Comments on Covariance Data of JENDL-4.0 and ENDF/B-VII.1

April 22, 2014

M. Ishikawa, JAEA

U-235 Fission (1/3)

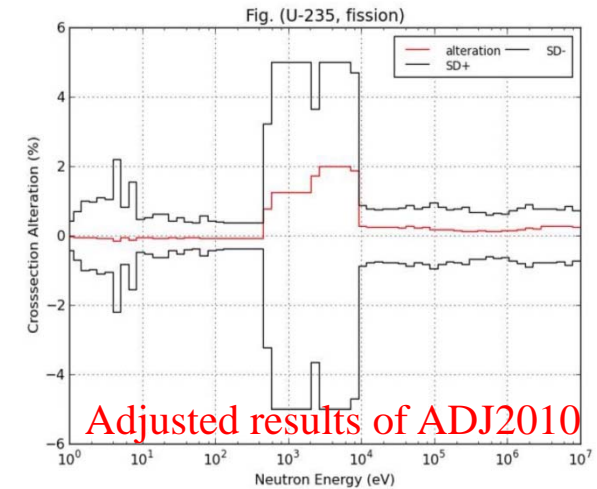
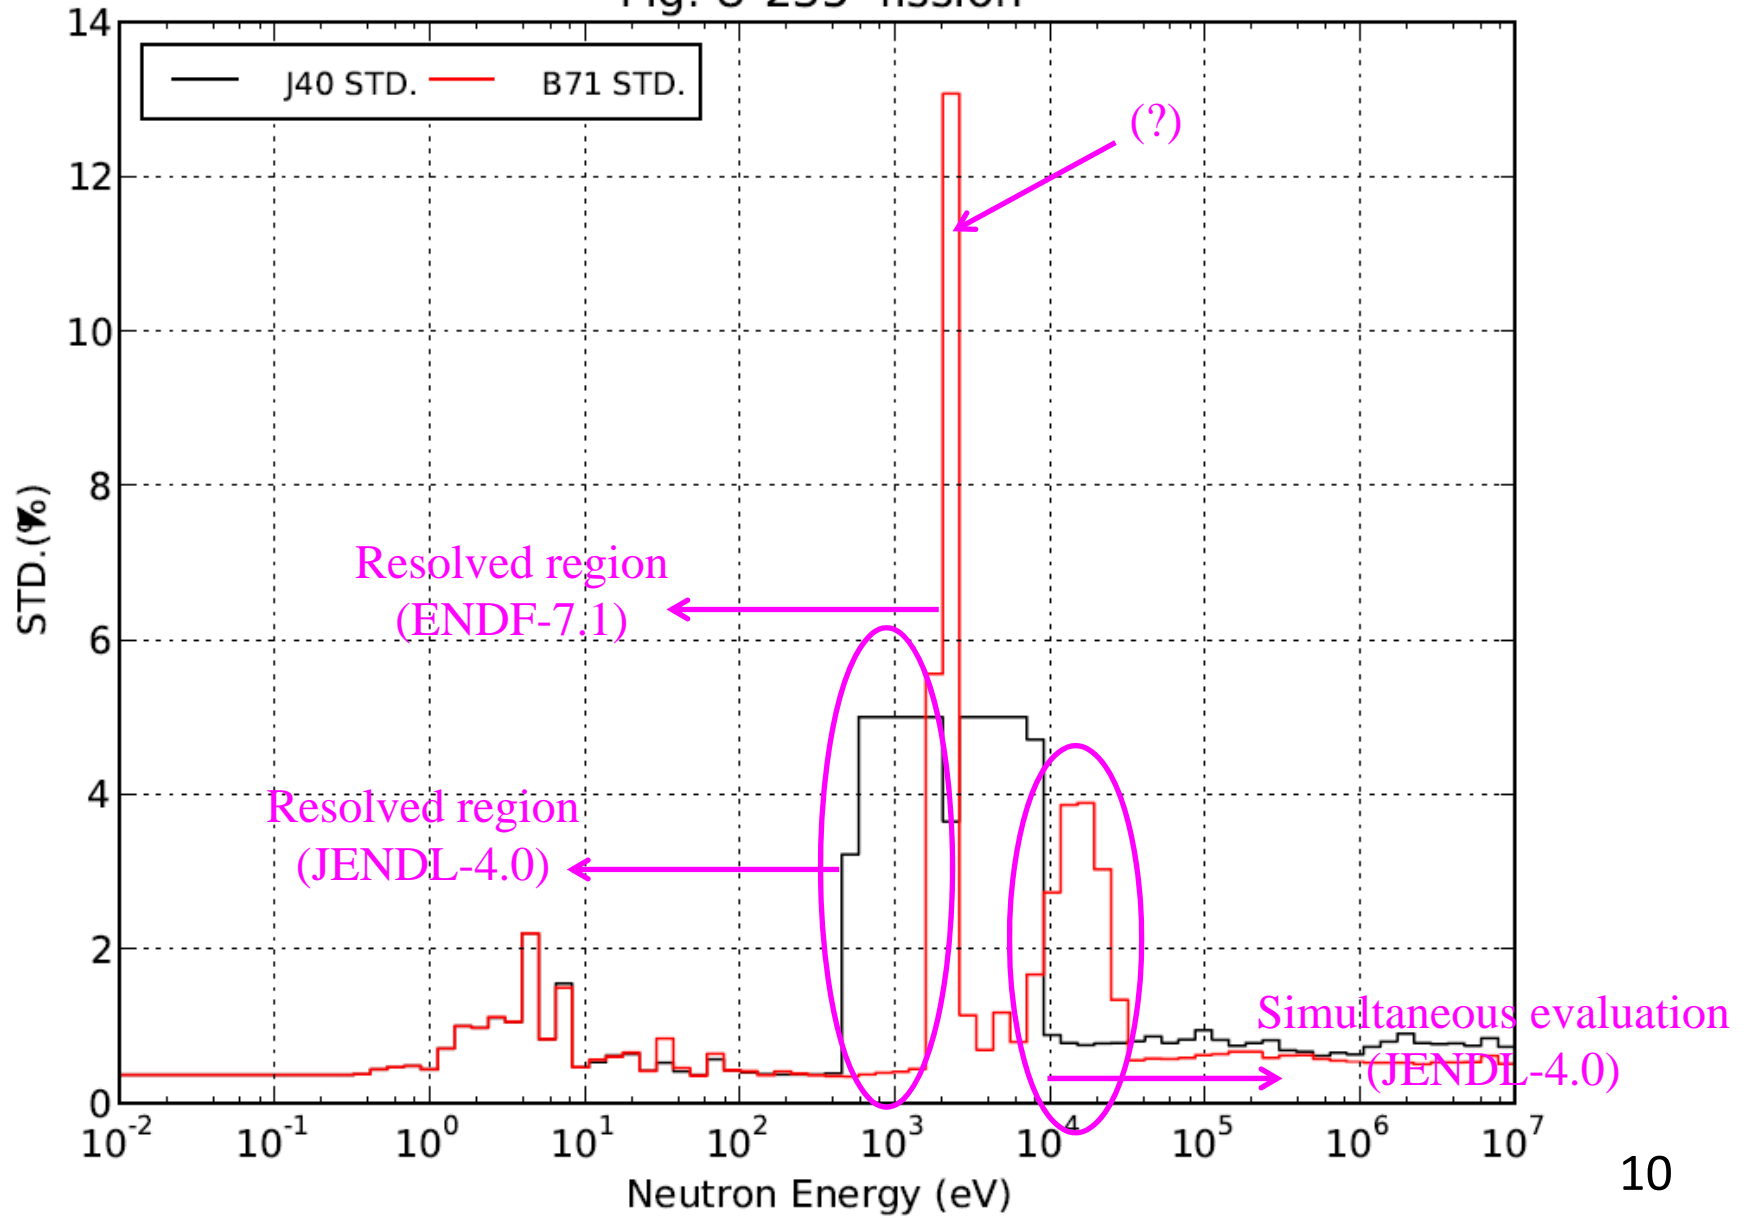
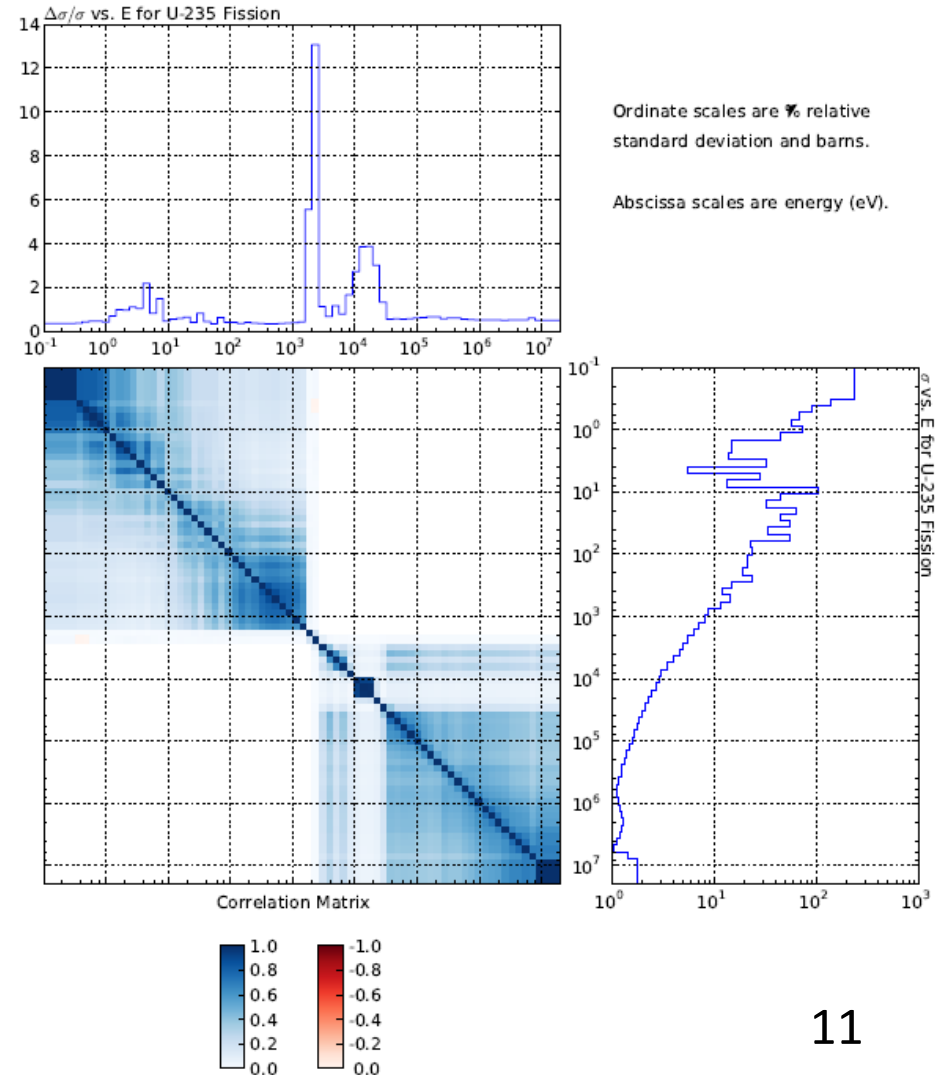
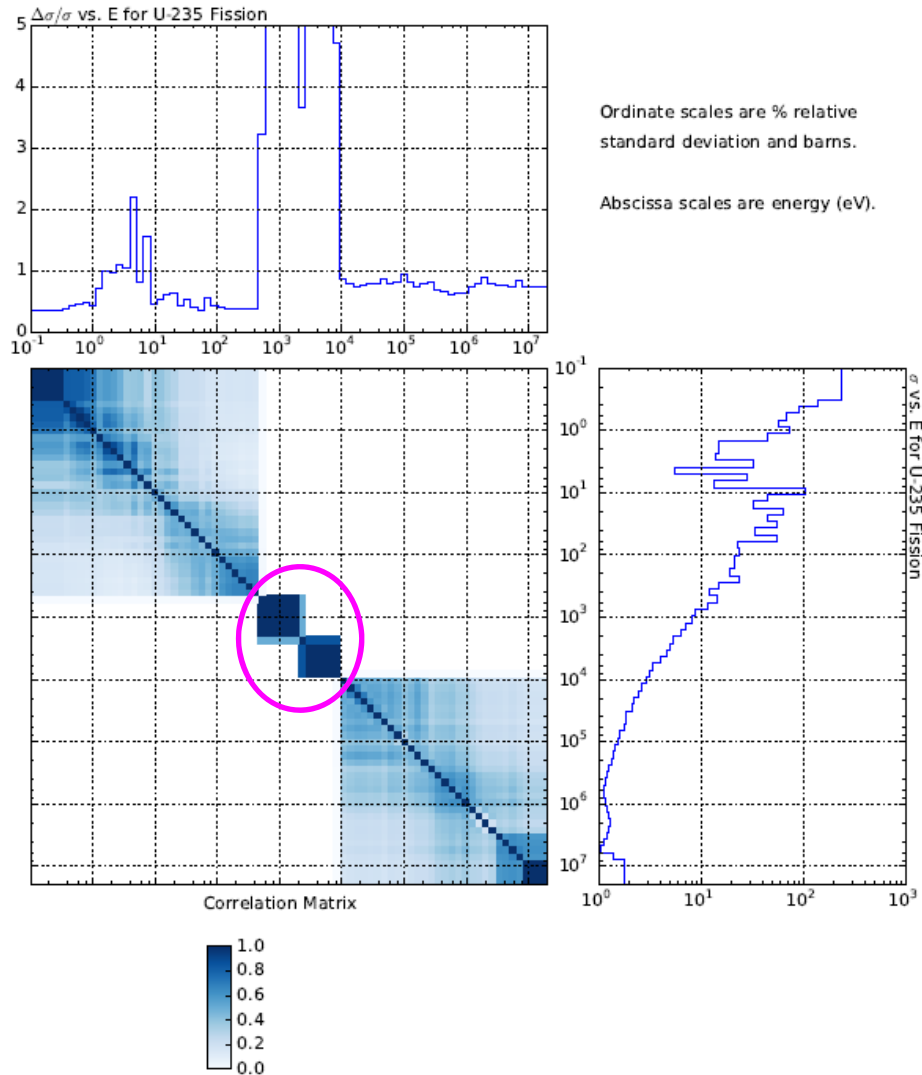
The **STD of ENDF-7.1 in 500eV~2keV** is **extremely small**, on the other hand, **JENDL-4.0** shows the large value of **5%**. Further, **ENDF-7.1** has very **sharp peak around 2keV**.

JENDL-4.0 adopted the resonance parameter values obtained from ORNL below 500eV(J-1), and re-evaluated based on those of ENDF/B-VI.5 (=JENDL-3.3) in the range of 500eV~2.25keV. In 2.25~9keV, the CCONE code was used, and above 10keV, the simultaneous evaluation was adopted. JENDL-4.0 assumed the STD value of 5% in 500eV~9keV(J-3), but the reason is unknown. The covariance of ENDF-7.1 was evaluated with GNASH-KALMAN(E-2, p.20), but the strange STD peak appears around 2keV.

SG39 should **ask the JENDL evaluators** about the reason of **5% in the range of 500eV~9keV**, and the **ENDF evaluators** on the explanation of the **sharp peak around 2keV**, which might be a problem of NJOY.

U-235 Capture (1/3)

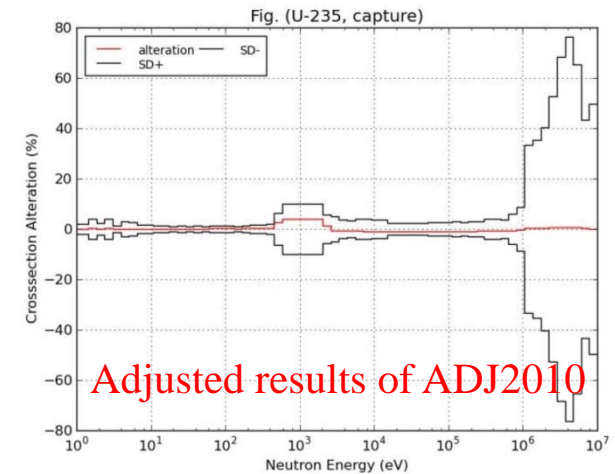
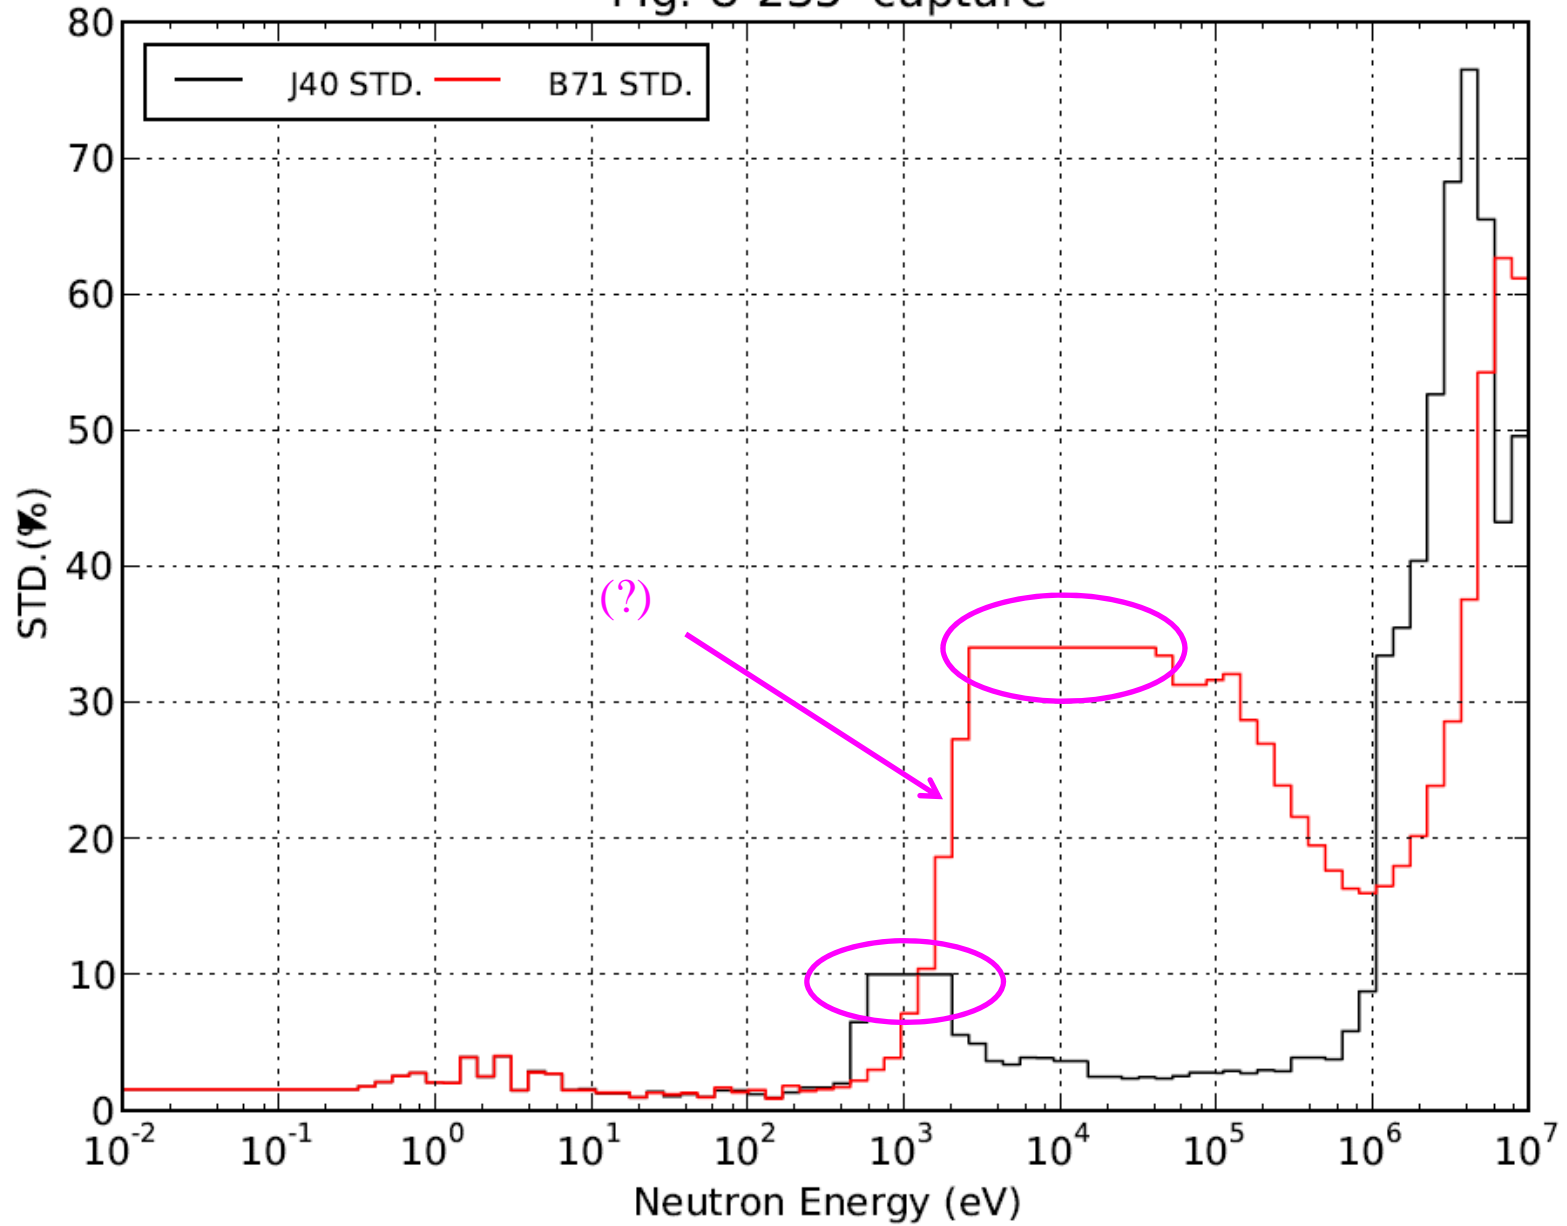
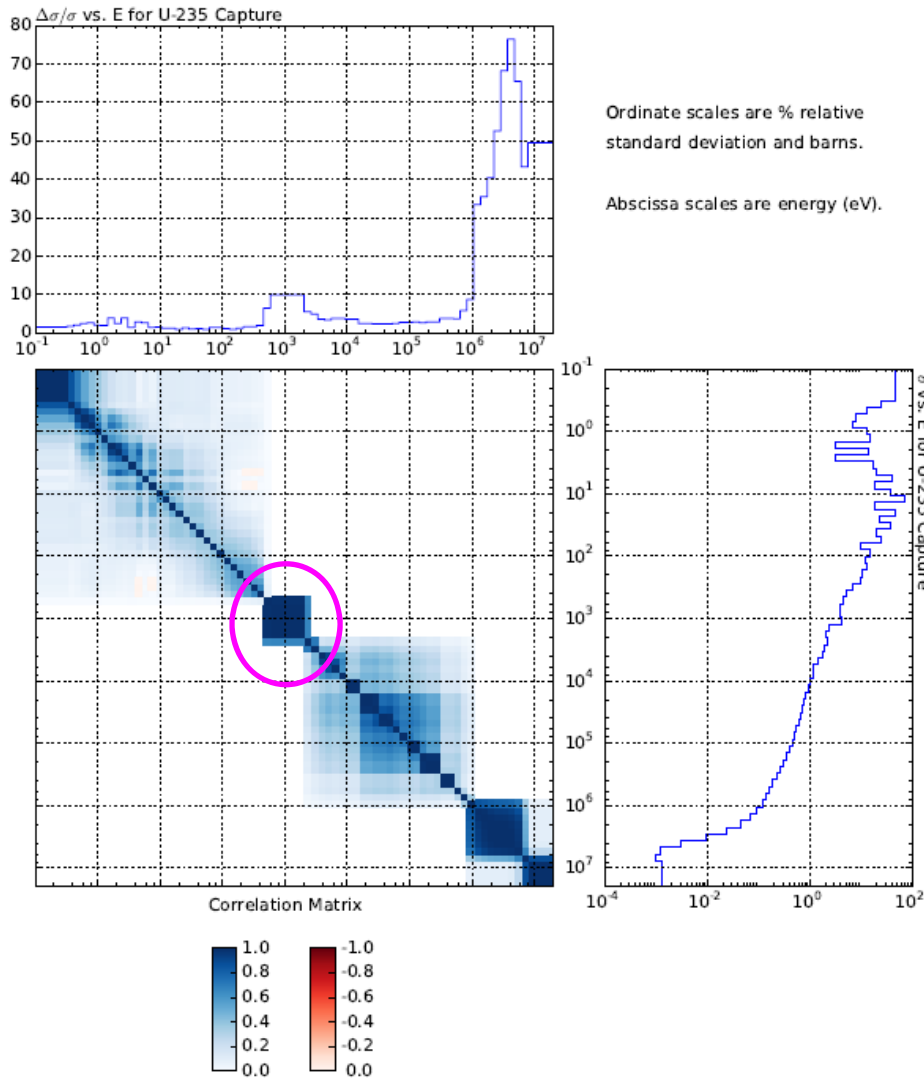
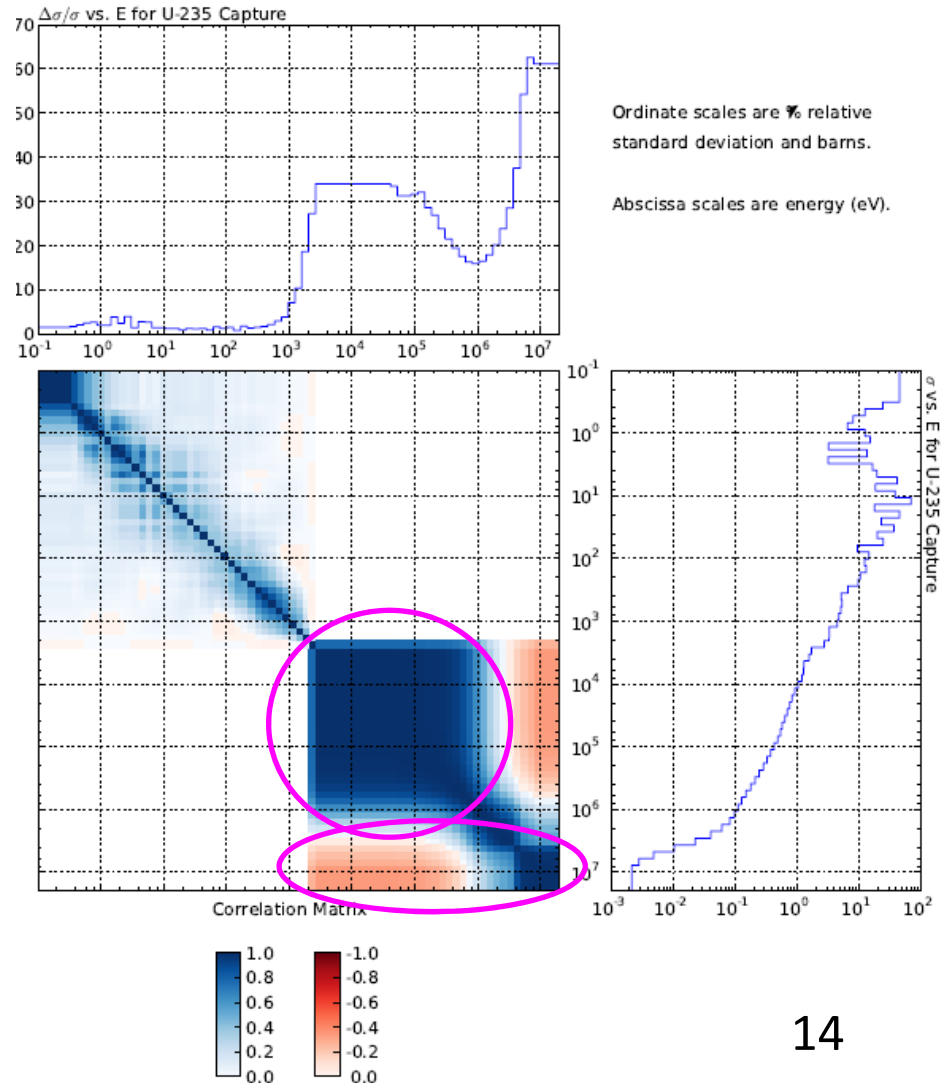
The STD of **JENDL-4.0** in **500eV~2.25keV** is **10% constant and perfect correlation**, on the other hand, **ENDF-7.1** increases from a few % to **35%**. In **2.25~30keV**, ENDF-7.1 gives the STD of **35% with almost perfect correlation**, while JENDL-4.0 shows **several % with weak correlation**. Further, the **negative correlation** with high energy region was found in ENDF-7.1, on the contrary, no such trend in JENDL-4.0.

The resonance parameters of JENDL-4.0 has the same explanation with U-235 fission, but the correction was added to make the cross-section close to that of JENDL-3.2 in 500eV~2.25keV^(J-1, p.7), and the uncertainty was assumed as 10%^(J-3). Above 2.25keV, the covariance was obtained the least-square calculation based on the experimental values of the alpha values, that is, the ratio to U-235 fission. The resonance parameters of ENDF-7.1 below 2.25keV adopted the ORNL results, but the constant STD of 35% would reflect the recent LANL measurements. The reason of the slope from several % to 35% is unknown.

SG39 had better confirm the **reasons of the observed facts** to both **JENDL-4.0** and **ENDF-7.1** evaluators.
